# City of Sunnyvale

TO: Planning Commission  
FROM: Mary Jeyaprasath, Project Planner  
PROJECT: 800 Carlise Way Well and Water Tank Project (2022-0741) Response to Late Comments on EIR  
AGENDA ITEM: 2  
DATE: March 9, 2026

This supplemental staff memo addresses questions and comments in letters on the Focused Environmental Impact Report for the project that the City received from four members of the public in the week before the Planning Commission meeting.

## 5/27/2025 Presentation to Planning commission

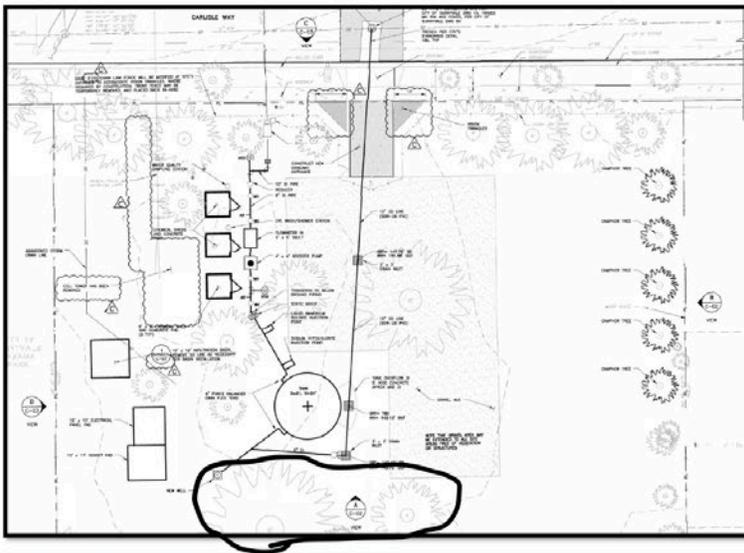
Presentation to Planning Commission 5/27/25, comment says 8 trees to be removed (up from the prior 4) **but no**
